SAN FRANCISCO PLANNING DEPARTMENT

Addendum to Environmental Impact Report

Addendum Date: February 17, 2016
Case No.: **2005.0161E**
Project Title: Calaveras Dam Replacement Project
FEIR: 2005.0161E, certified January 27, 2011
Project Sponsor: San Francisco Public Utilities Commission
Lead Agency: San Francisco Planning Department
Staff Contact: Timothy Johnston – (415) 575-9035
timothy.johnston@sfgov.org

FIGURE 1

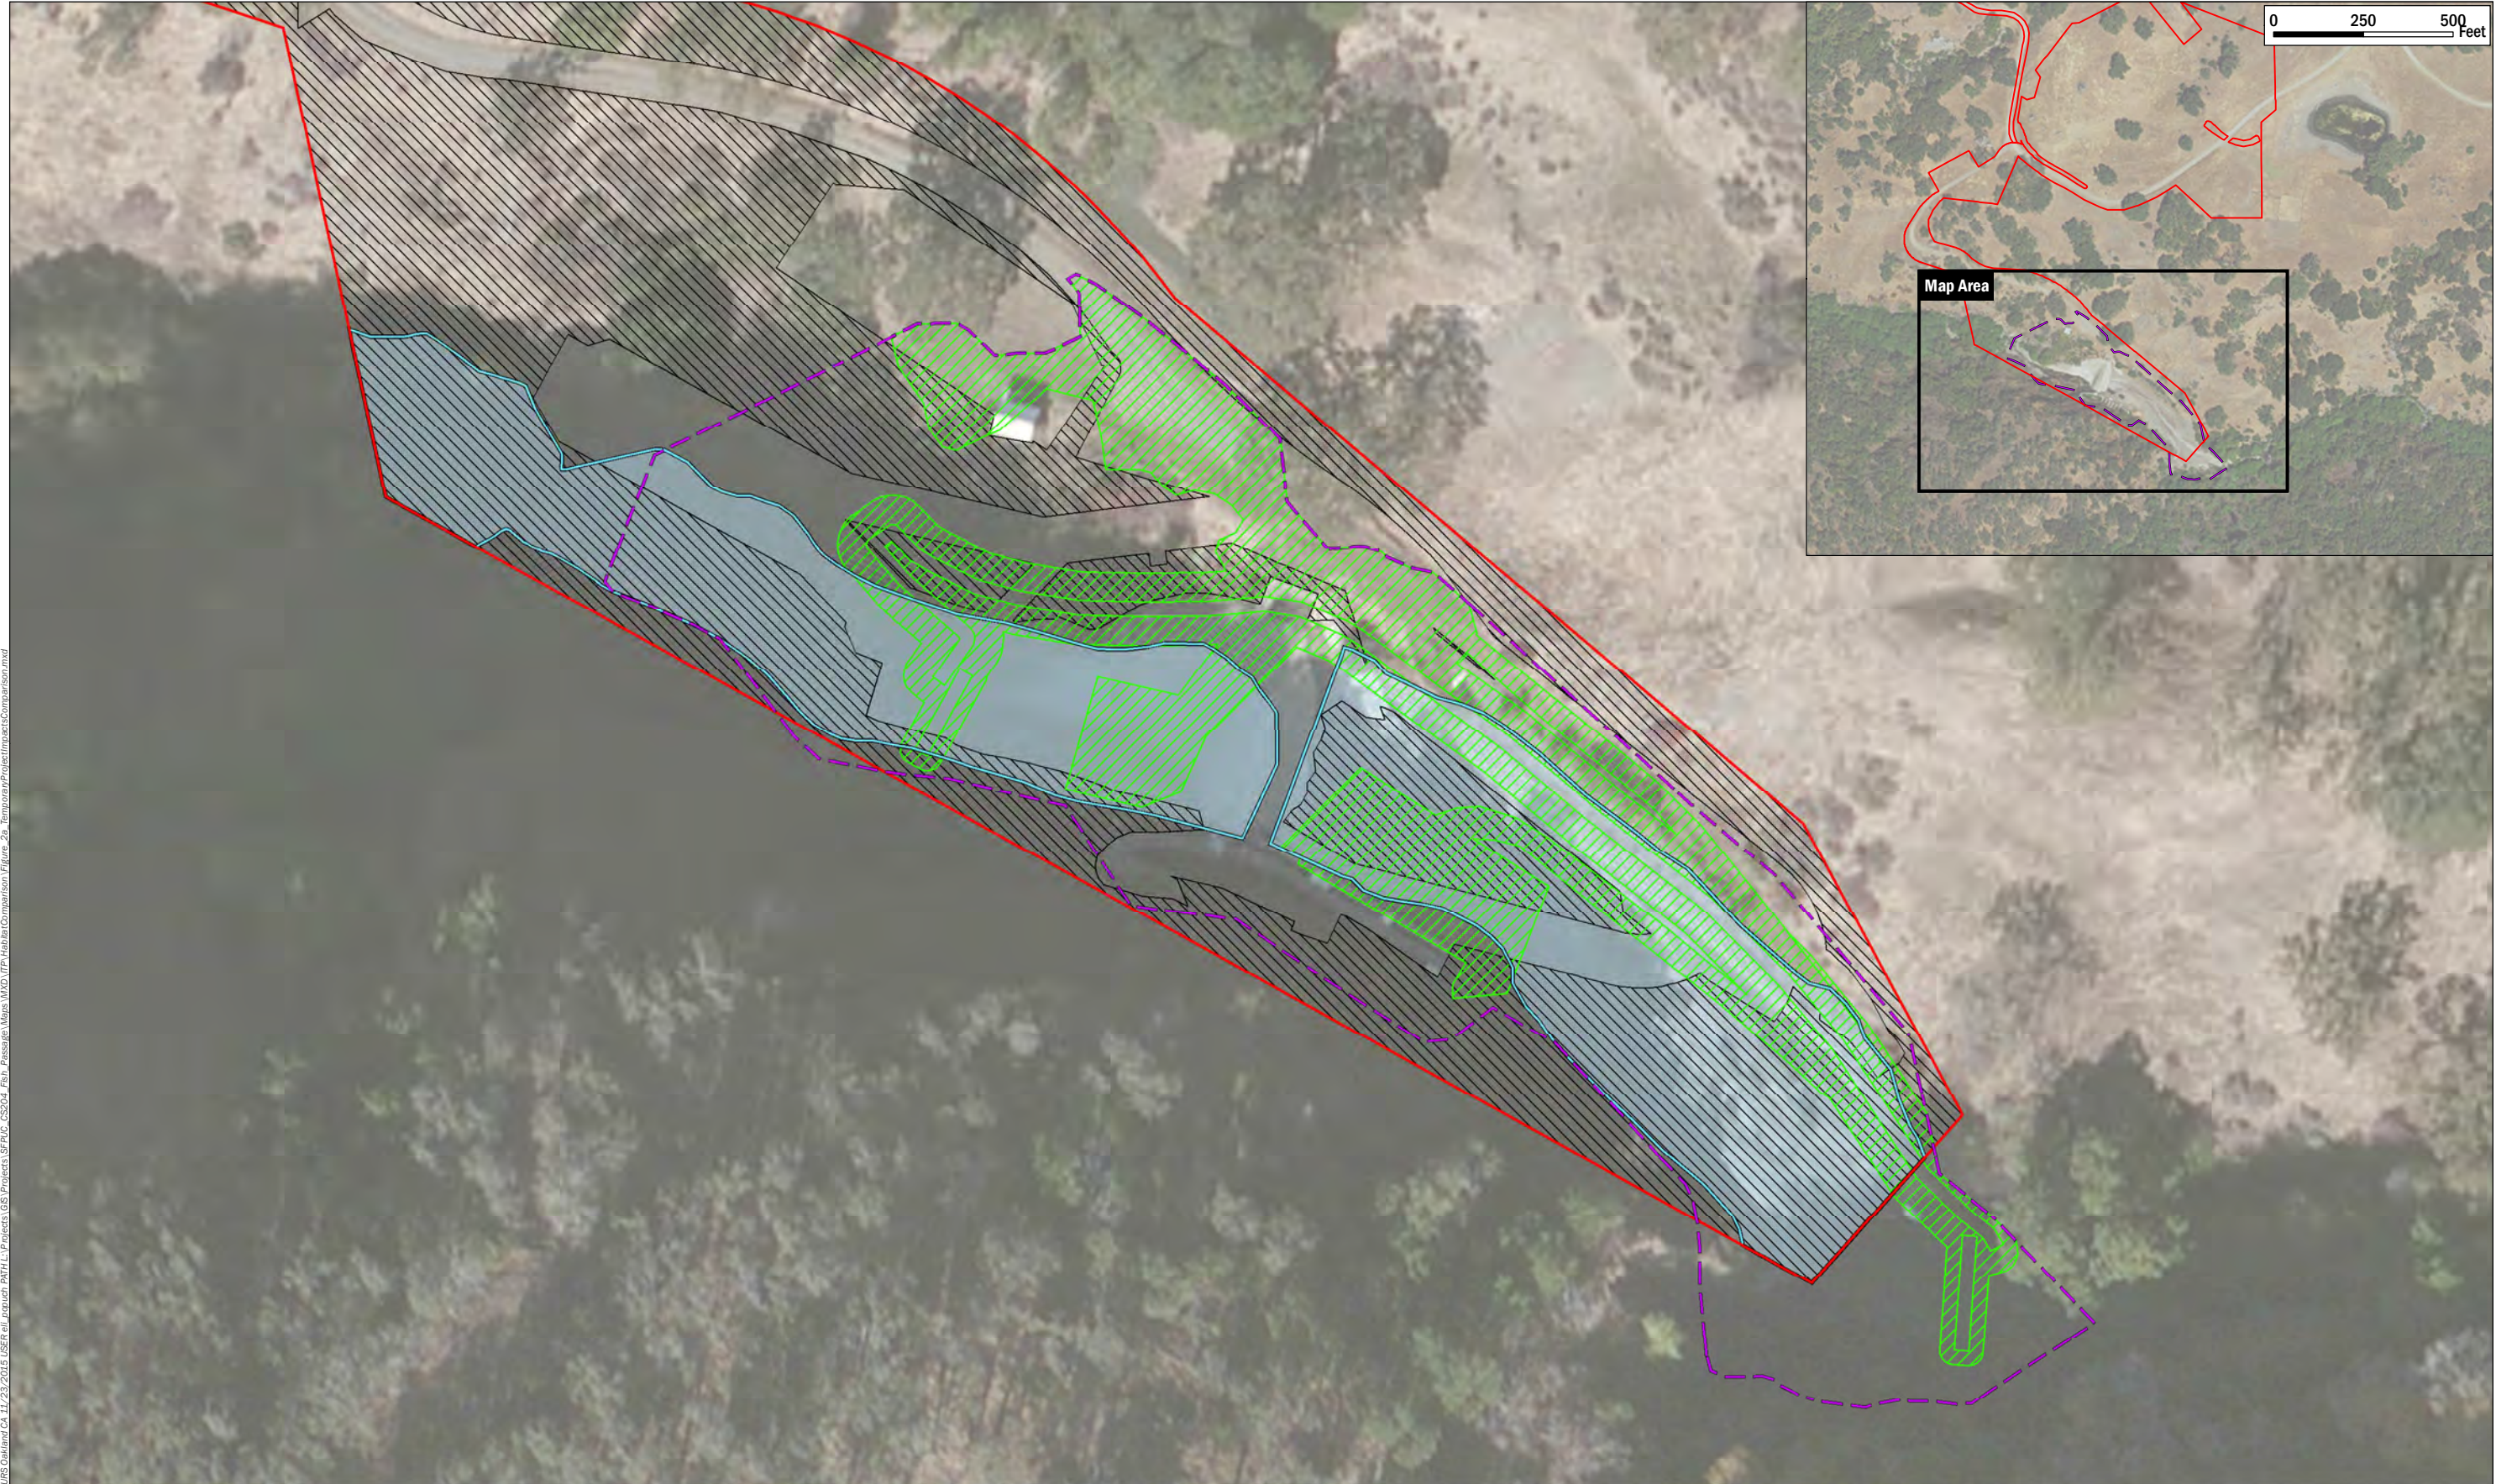
The FEIR indicates that staging areas will occur in the immediate area to be used for construction of the ACDD fish ladder, screens, and associated facilities. This modification proposes to use several additional

staging areas as shown on Figure 1. Staging Area 1-1 located on the north side of Camp Ohlone Road would be used for the permanent disposal of the approximately 25,000 cubic yards of excess spoil (soil and rock) that would be generated. To facilitate this, several trees would be removed and the spoil would be incorporated into the existing slope and seeded with a native grassland mix. Staging Area 1-2, located on each side of Camp Ohlone Road between Staging Area 1-1 and the main work area, would be used for material storage and deliveries. Staging Area 1-3, on the south side of Camp Ohlone Road adjacent to Staging Area 1-1 and the communications tower, would be used for office trailers, and a storage area. Lastly, two staging areas that were utilized during the SFPUC's recent Geary Road Bridge Project would be used: Staging Area 1-4 is on the south side of Geary Road Bridge and Staging Area 1-5 is within the East Bay Regional Park Corporation Yard. These would be used for construction trailers and equipment storage or deliveries as necessary. Upon project completion, these staging areas would be restored to approximately pre-construction conditions; i.e., non-native annual grassland, except for Staging Area 1-1 where the excess spoils would be placed. The spoils pile would vary in final contour from pre-construction condition; however it would be seeded and thus restored to non-native annual grassland.

FIGURE 2A

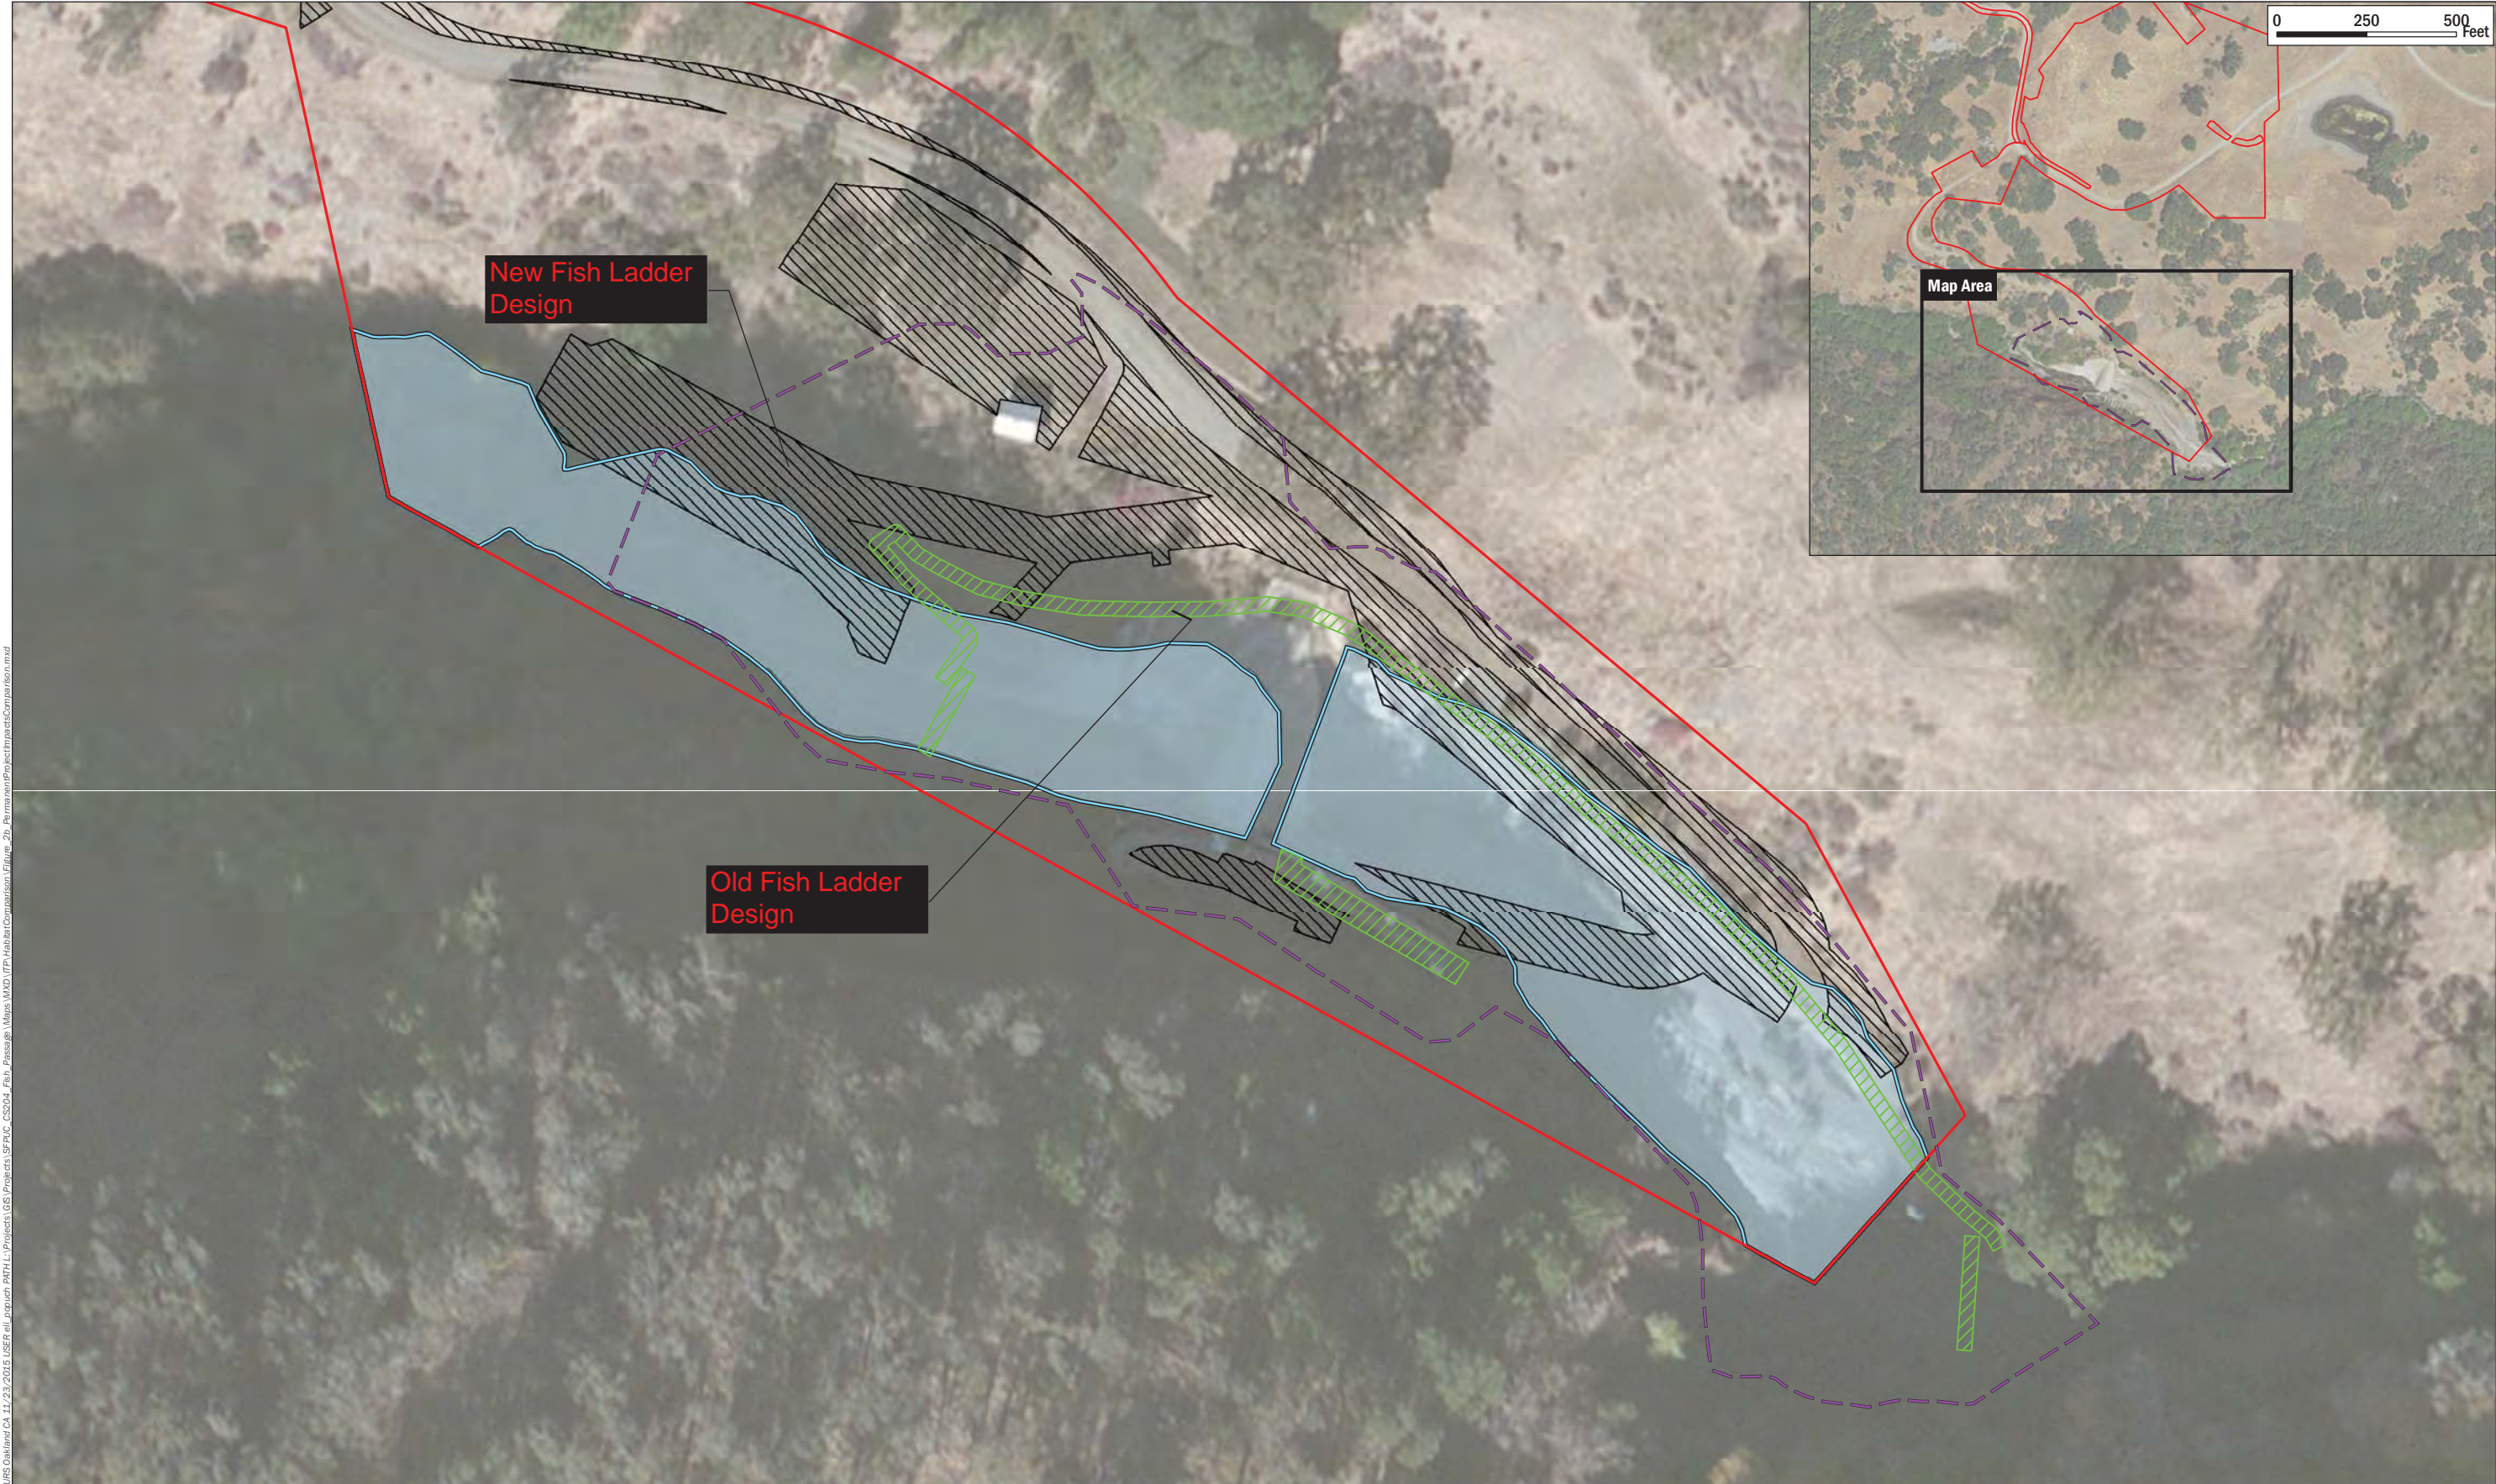
The proposed updates to the ACDD project would affect vegetation and wildlife (Figures 2a and 2b). The majority of the additional impacts would occur in upland habitat. The modified project would result in an additional 10.04 acres of temporary and 0.97 acres of permanent impacts to upland habitat (11.01 total acres). Relative to the total 672.5 total acres of upland impacts disclosed in the FEIR and subsequent addendums, the modified project would increase impacts by less than two percent. This represents an incremental increase in impacts on special status species upland habitat. As with the adopted project, under the modified project, pursuant to Mitigation Measures 5.4.2 (Habitat Restoration Measures), the SFPUC would restore the additional area of temporary habitat impacts. Under Mitigation Measure 5.4.3a, the SFPUC would compensate for the additional permanent impacts relating to a loss of upland habitat for California red-legged frog, California tiger salamander, and Alameda whipsnake by enhancing and/or protecting and maintaining upland habitat at one or more mitigation areas, with resource agency concurrence. Five mitigation areas are described in the FEIR: Grimes, San Antonio, Sheep Camp Creek, Goat Rock, and Goldfish Pond. Adequate and feasible opportunities are available at the Goat Rock Mitigation Area to fully compensate for the additional upland habitat impact.⁸ Construction activities within this additional area would also, in turn, increase the potential to encounter and impact the special status species listed above that use upland habitat as refuge and/or dispersal habitat. As with the adopted project, measures would be implemented to avoid and minimize impacts to listed species within upland areas during construction, pursuant to Mitigation Measure 5.4.1 (Avoidance and Minimization Measures), including, wildlife exclusion fencing, pre-construction surveys, and monitoring. Therefore, the modified project would not result in any new significant effects on upland habitat and species that use this habitat beyond those identified in the FEIR or substantially increase the severity of a significant impact, and no new mitigation measures would be required.

The modified project would result in an additional 0.4 acres of temporary and 0.11 acres of permanent impacts to aquatic habitat (11.01 total acres) (Figures 2a and 2b). Relative to the total 39.33 acres of aquatic impacts disclosed in the FEIR and subsequent addendums, the modified project would increase impacts by about three percent. This represents an incremental increase in impacts on aquatic habitat for special status species. As with the adopted project, implementation of Mitigation Measures 5.4.2 (Habitat Restoration Measures) and 5.4.3 (Compensation Measures) would reduce these impacts to wetlands and other aquatic habitats to a less-than-significant level. As also with the adopted project, during construction in the additional aquatic habitat, species could be affected if present and sediment or other pollutant discharges could be released during excavation for the fish ladder and screens and during transport to the disposal site, which could degrade wetland and stream habitat. However, as also with the adopted project, implementation of Mitigation Measures 5.4.1 (Avoidance and Minimization Measures) and Mitigation Measure 5.7.1 (Storm Water Pollution Prevention Plan) would minimize or avoid these impacts to the extent feasible and would minimize water quality degradation. These same measures would be implemented under the modified project, which would similarly maintain these impacts to wetland and other aquatic habitats at less-than-significant levels. Therefore, the modified project would not result in any new significant effects on wetlands, streams or riparian habitats beyond those identified in the FEIR or substantially increase the severity of a significant impact, and no new mitigation measures would be required.
